Re: PETITION NO. 1601 – TRITEC Americas, LLC notice of election to waive exclusion from Connecticut Siting Council jurisdiction, pursuant to Connecticut General Statutes §16-50k(e), and petition for a declaratory ruling, pursuant to Connecticut General Statutes §4-176 and §16-50k, for the proposed construction, maintenance and operation of a 0.999-megawatt AC solar photovoltaic electric generating facility located at 958 Route 163, Montville, Connecticut, and associated electrical interconnection. **Petitioner Responses to Interrogatories from Council.**

**Petition No. 1601
TRITEC Americas, LLC
958 Route 163, Montville, Connecticut**

**Interrogatories
February 7 2024**

Sheet Title: **SITE LAYOUT PLAN** Sheet #: **2.11**

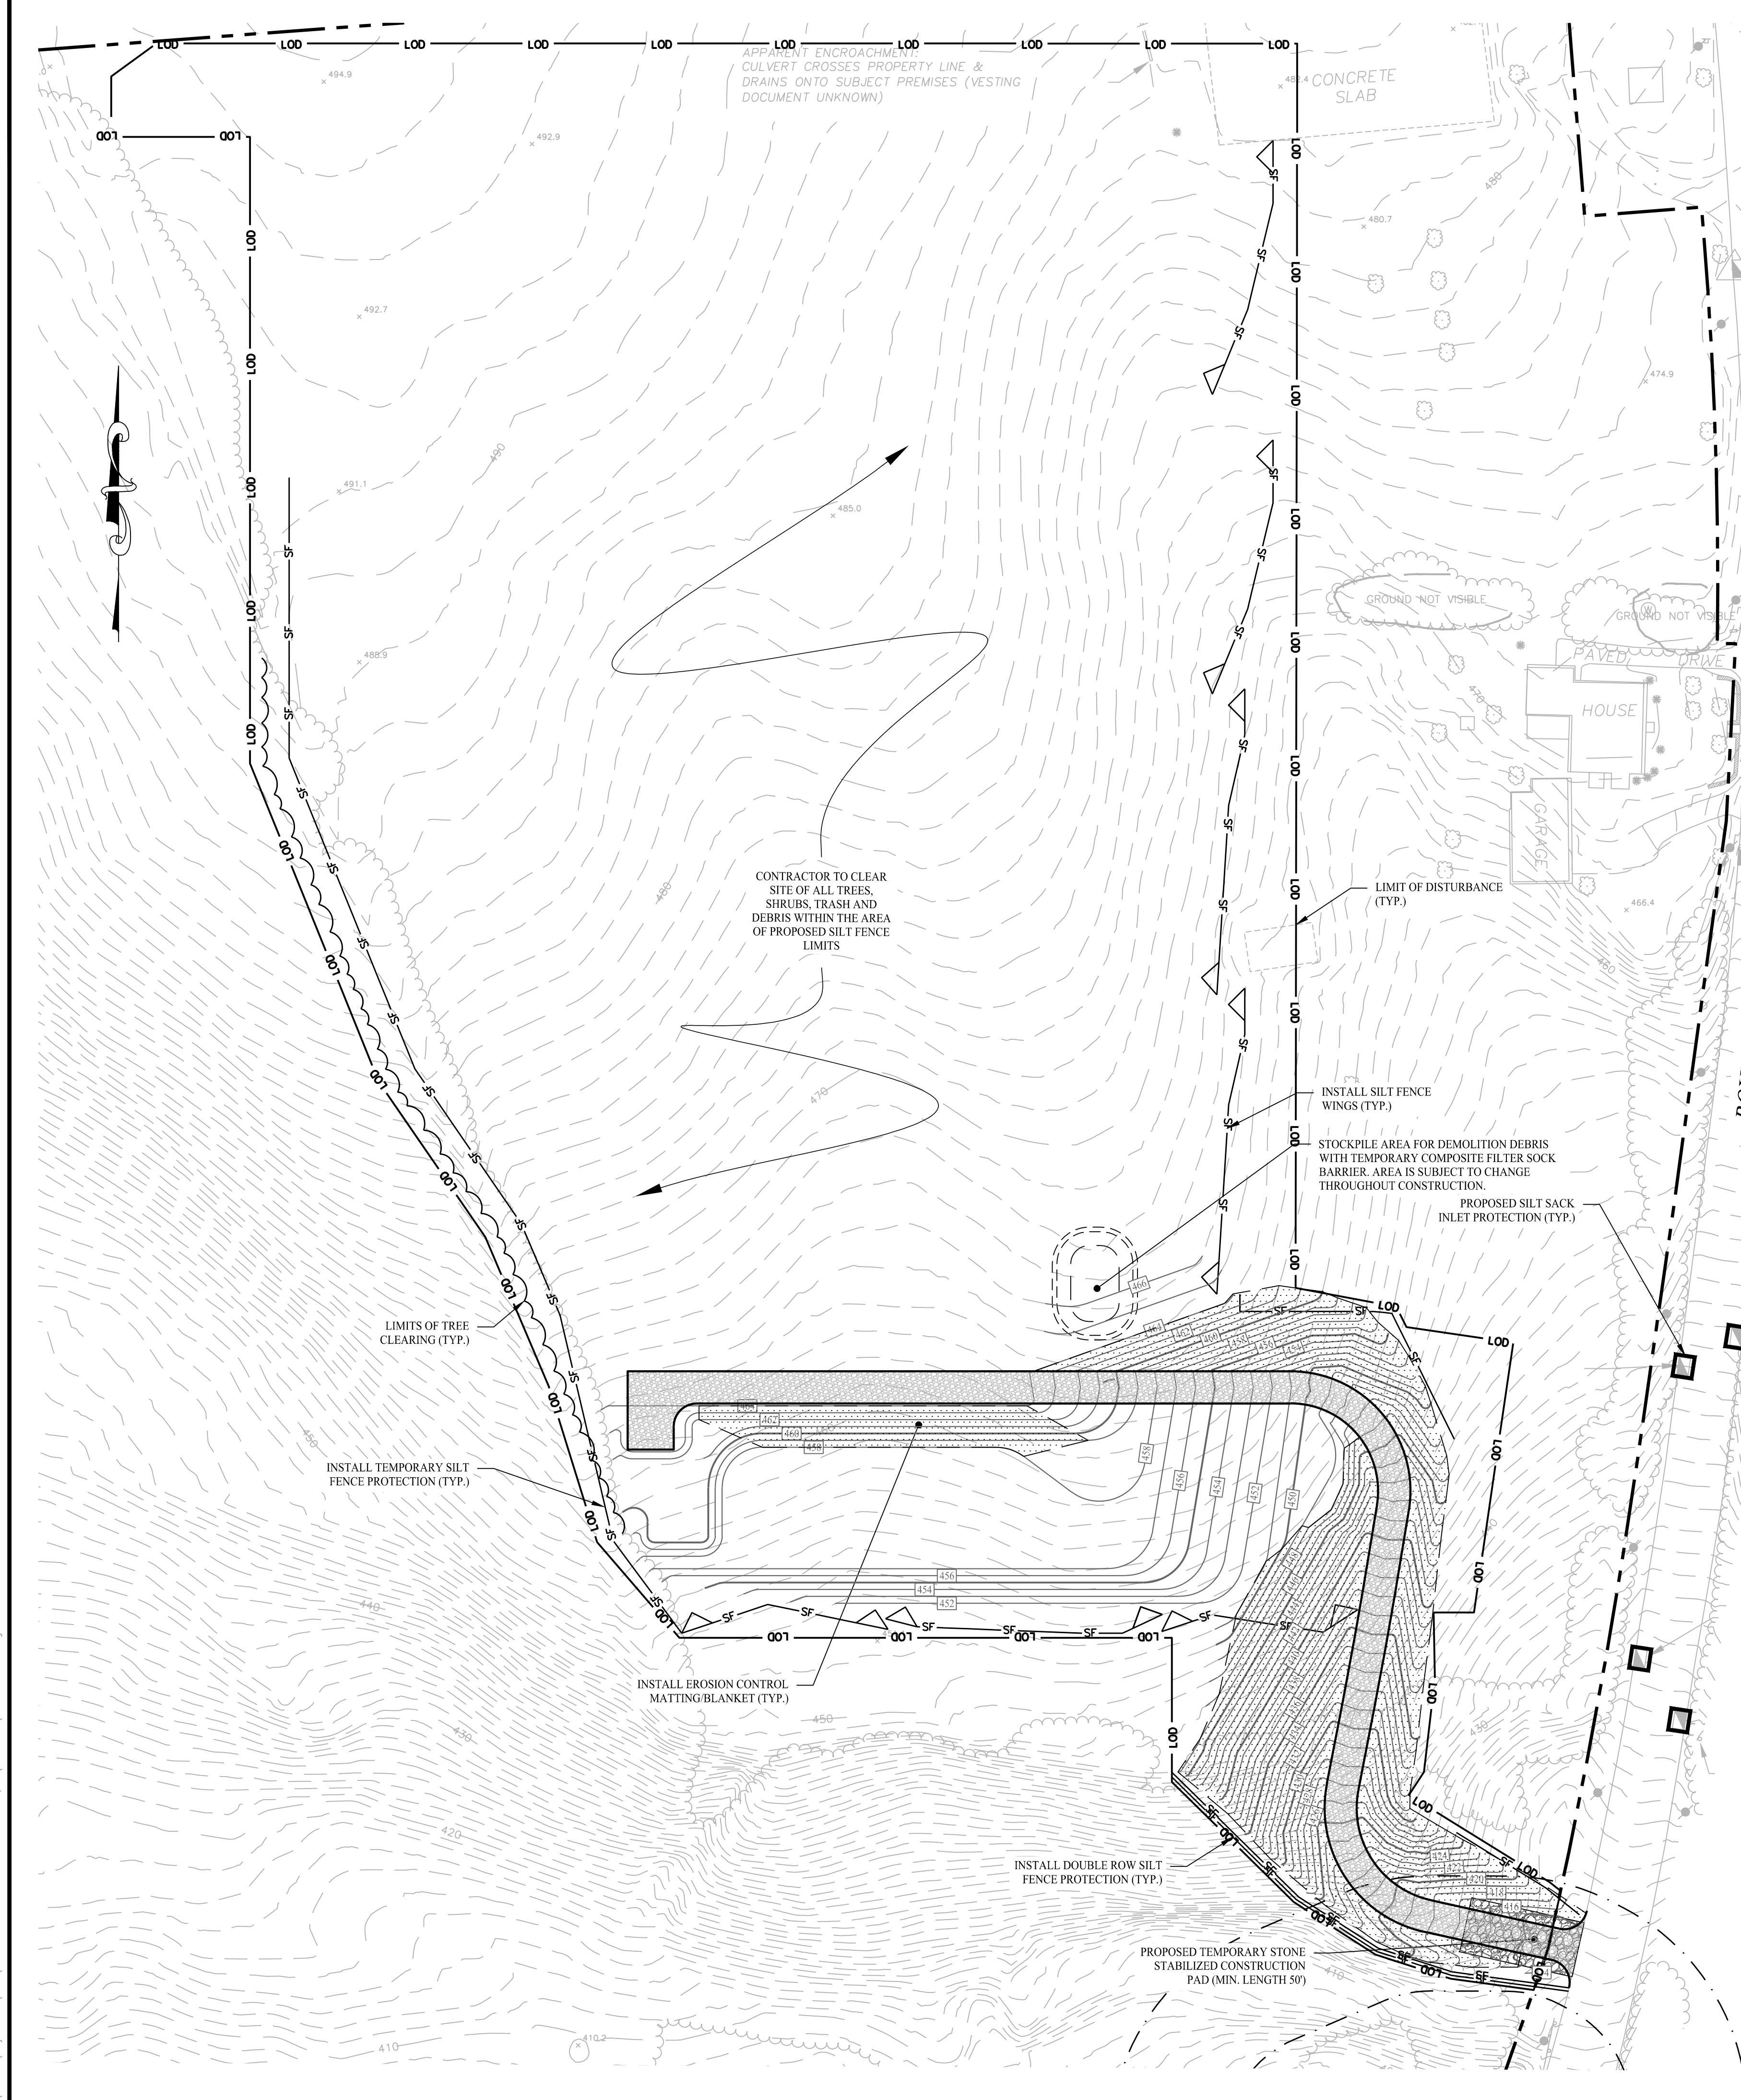
21. Referencing Petition Site Plan 2.11, why do the utility poles need to be within 10 feet of each other? Can some or all the utility poles be located farther to the west?

22. Referencing Petition Site Plan 2.11, the proposed interconnection route is shown passing through a vegetated area. Describe clearing necessary to install the interconnection line.

RESPONSE: The Site Layout Plan 2.11 has been modified to provide 40-foot spacing between the (3) Eversource-owned utility poles and 30-foot spacing between the (2) customer-owned poles. The poles are placed along the proposed access drive. Ultimately Eversource will dictate the exact details of the interconnection as it pertains to quantity and spacing of poles, however the proposed alignment is based on recent projects of similar size. Enclosed, please see, "Site Layout Plan 2.11."

RESPONSE: The Site Layout Plan 2.11 has been modified to relocate the interconnection route along the proposed access drive. This relocation will not require additional tree/vegetation clearing. Enclosed, please see, "Site Layout Plan 2.11."

Sheet Title: SOIL EROSION & SEDIMENT CONTROL PLAN PHASE I
 Sheet #: 2.31

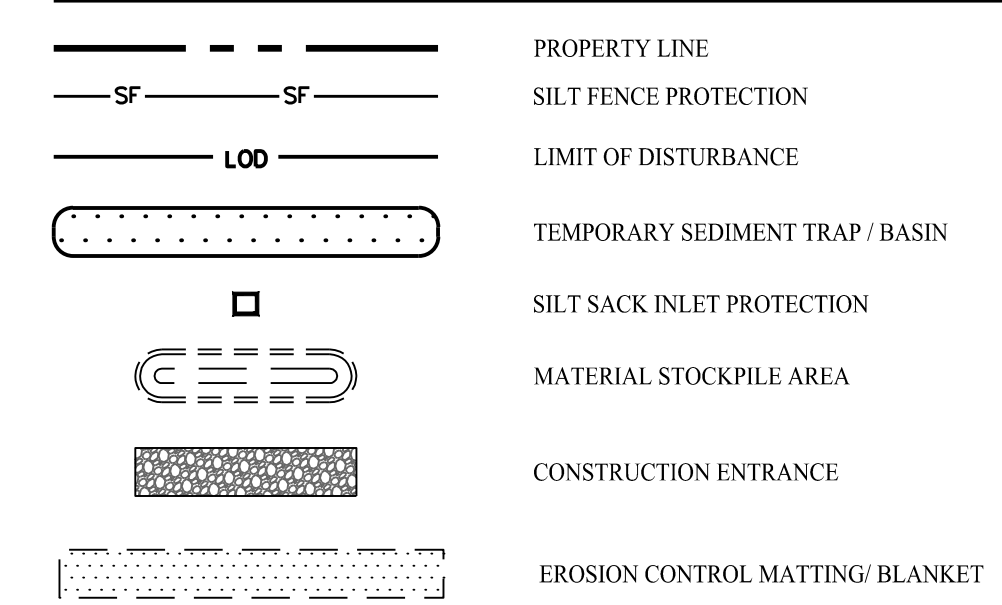
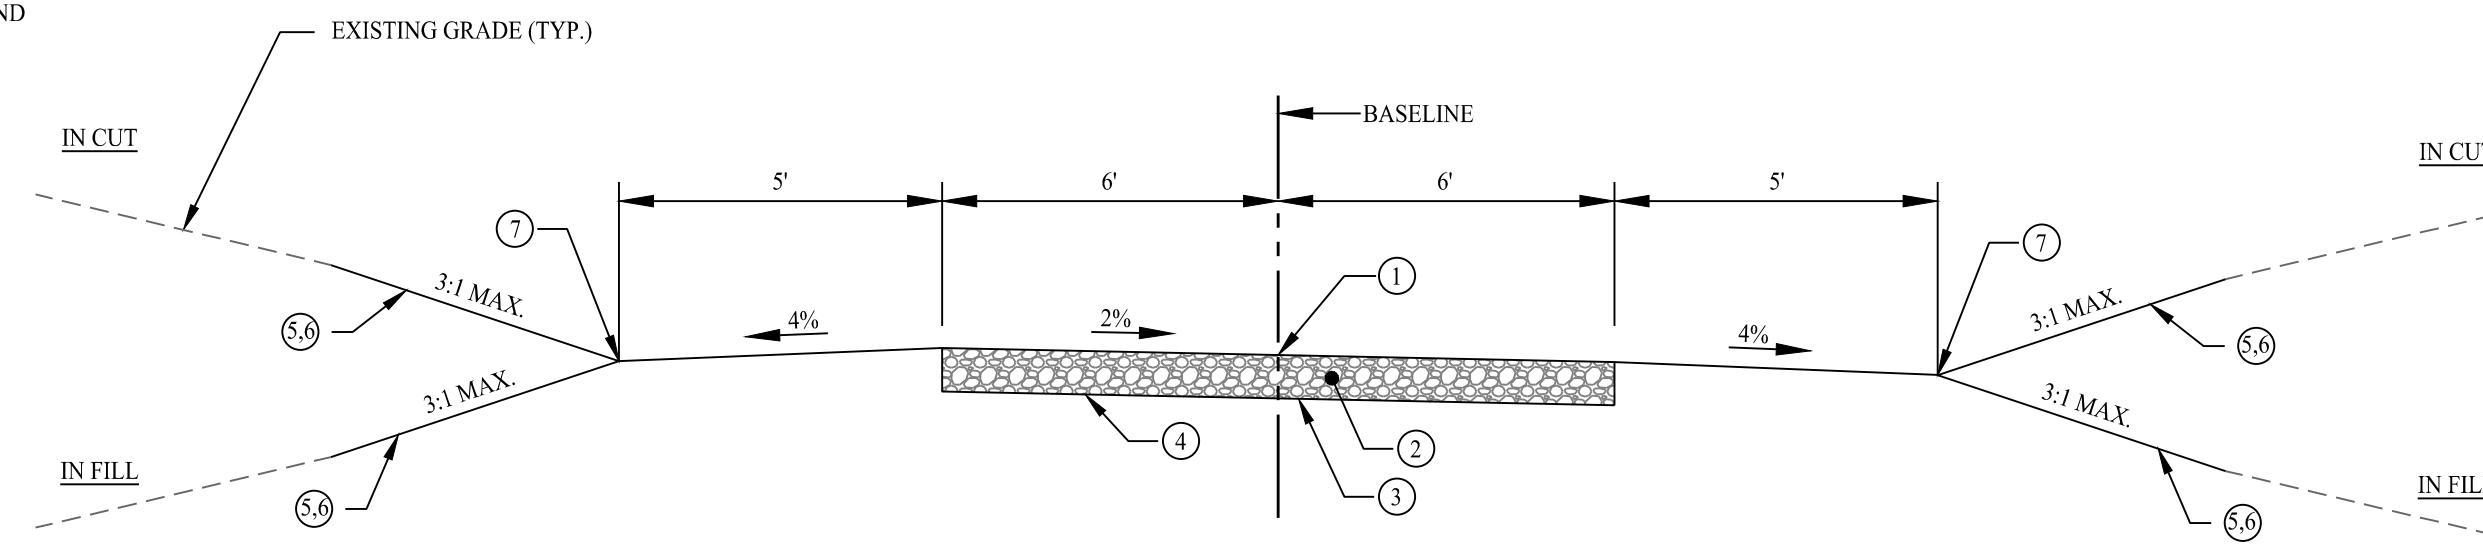
38. Petition Site Plan 2.31 shows the stormwater detention basin as being constructed as part of Phase 1; however, the Site Plan 2.32- Phase 2 narrative describes the basin as being constructed after the installation of the solar panels. Clarify.

RESPONSE: The Soil Erosion & Sediment Control Plan Sheet 2.31 has been modified to remove the installation of the stormwater detention basin during Phase 1. Sections of silt fence with wings are provided along the LOD to prevent sediment from leaving the site. This measure is typically utilized for drainage areas of less than 1-acre per the 2024 Connecticut Guidelines for Soil Erosion & Sediment Control. The stormwater detention basin is proposed to be installed during Phase 2 of construction. Enclosed, please see, "Soil Erosion & Sediment Control Plan Phase I 2.31."

7' HIGH CHAIN LINK FENCE DETAIL

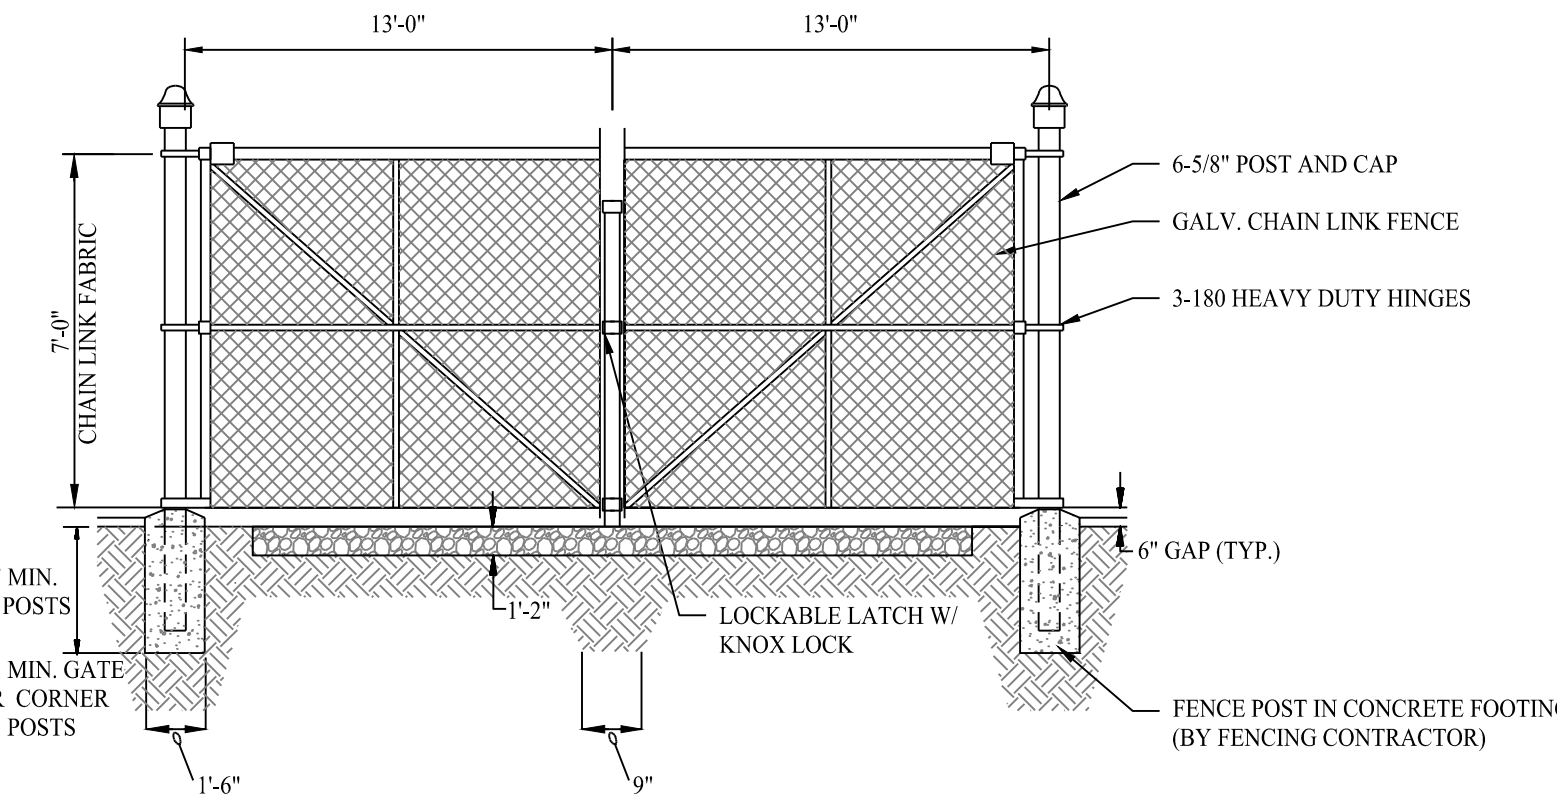
32. Referencing Petition Site Plan 3.01- Fence Detail, can the bottom of the perimeter fence fabric be raised to a height of six-inches above grade to allow for small wildlife movement?

RESPONSE: The proposed fence detail has been modified accordingly. Please see “Details Sheet 3.01.”

NYLOPLAST DRAIN BASIN (YARD DRAIN) DETAIL

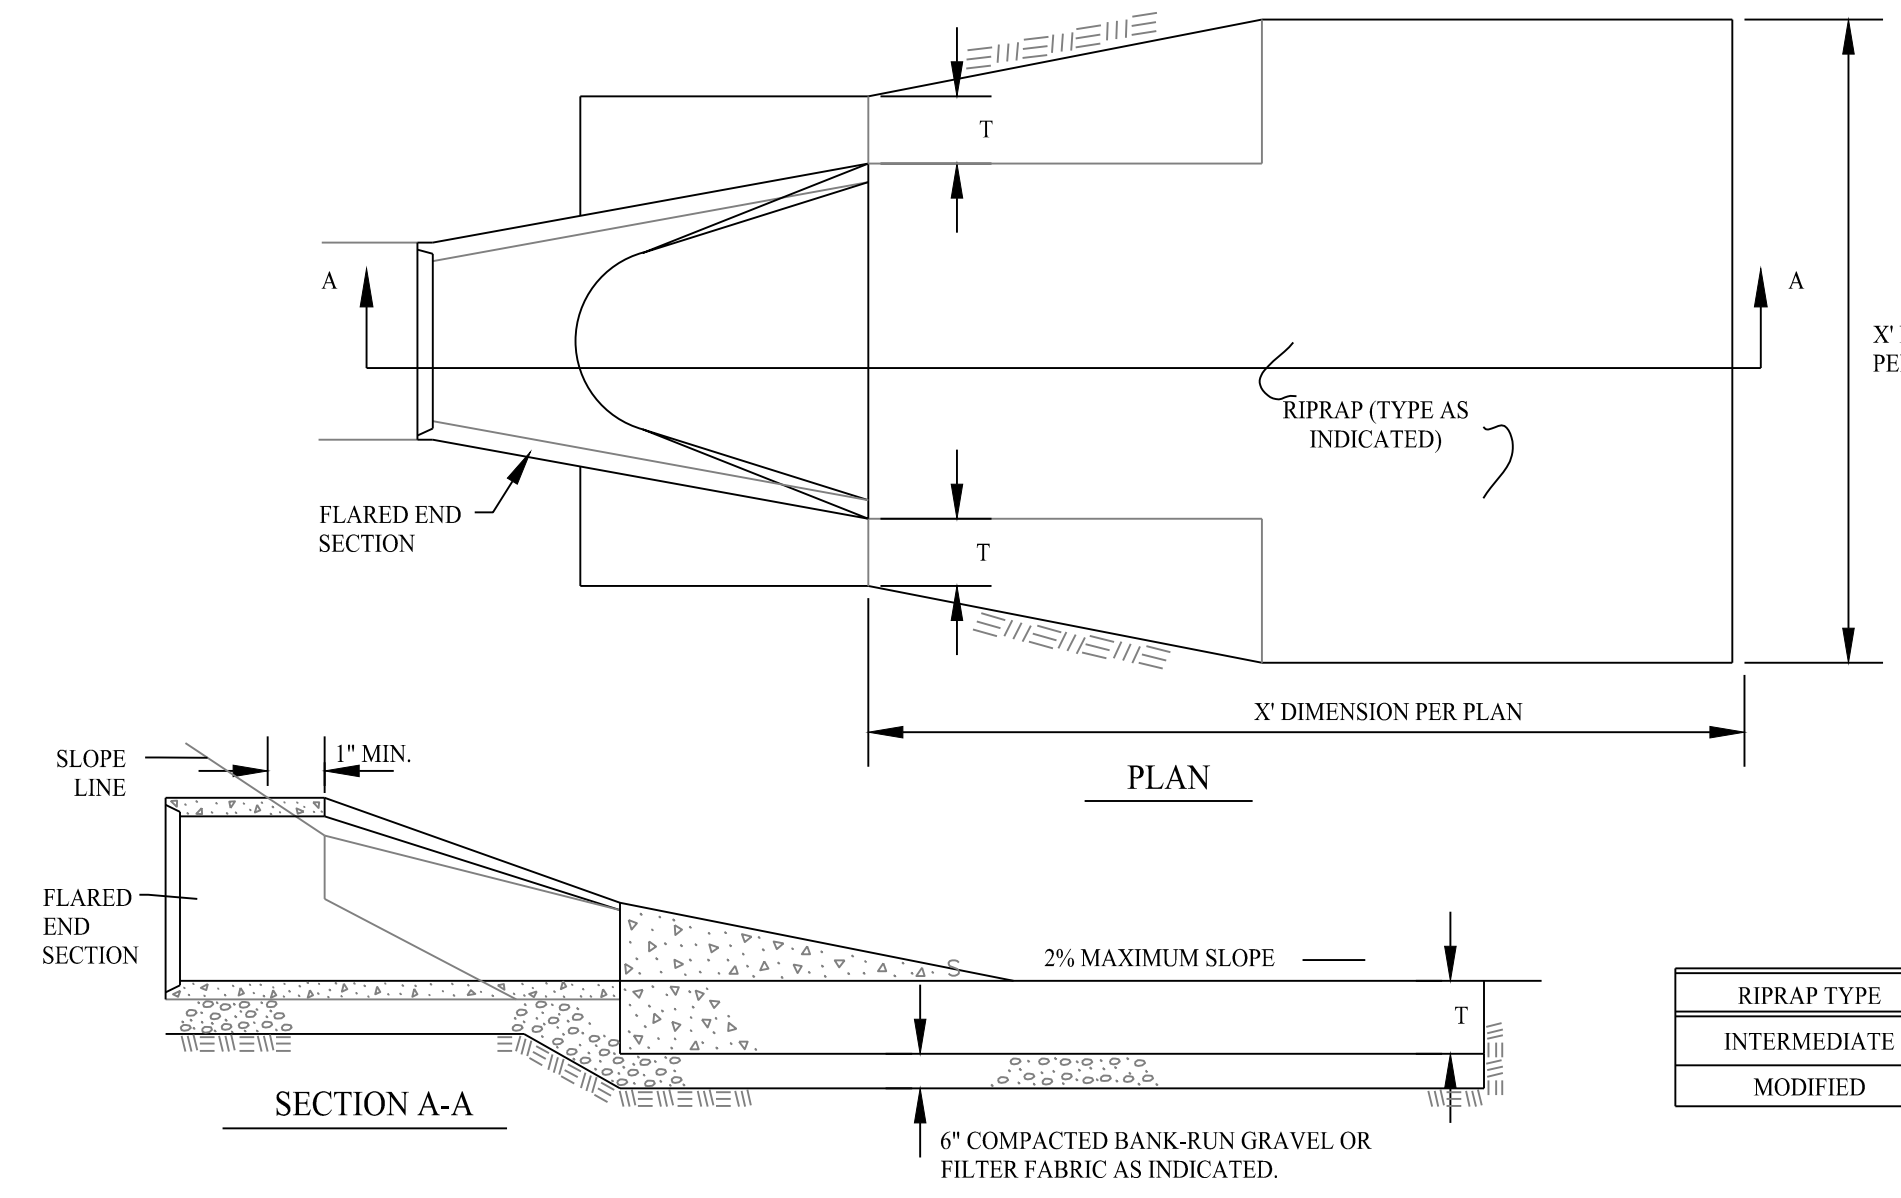
40. Referencing Petition Site Plan 2.21, provide more information of the function of the "yard drain" and how stormwater will be directed to the drain.

RESPONSE: All efforts were made to minimize the amount of grading necessary within the Project area, however due to the location of the access drive there is some runoff that will be directed towards it. The intent of the "yard drain" is to capture some of the runoff that cannot be directed into the stormwater detention basin due to the site grading.
